**Comments from the Forestry Department
On the Environmental Impact Assessment governing
the Proposed Mining Operation in SML 173**

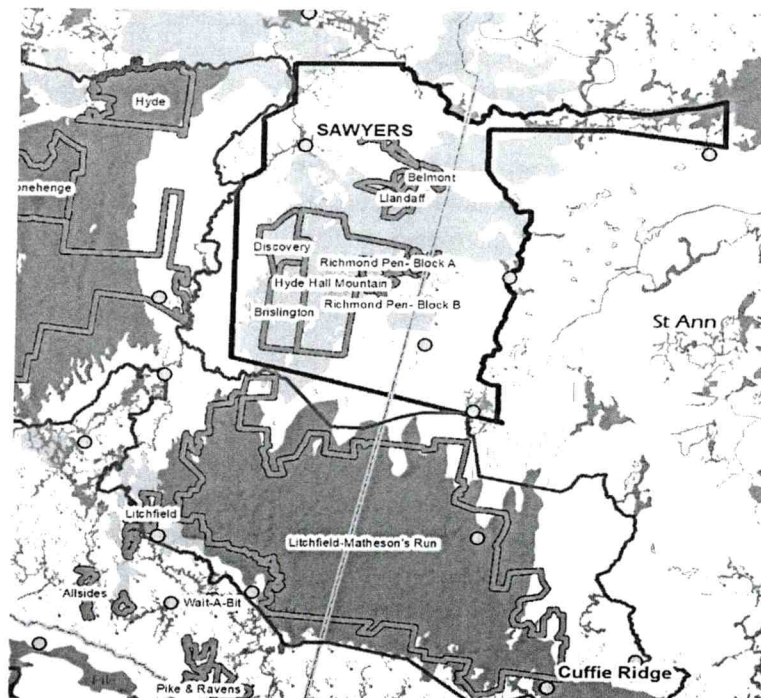
Though the majority of the forest cover on the hillocks will not be impacted directly by the mining operation, what will be annihilated is the ecological corridors that are the bridges between the hillocks. Floral and or faunal populations will become confined to these hillocks and it is highly probable that the numbers will become reduced and hence vulnerable over time if these corridors are not re-established. Additionally, access to each hillock increases significantly; It is therefore likely to see increase of yam stick harvesting and charcoal production thus leading to forest degradation and eventually deforestation.
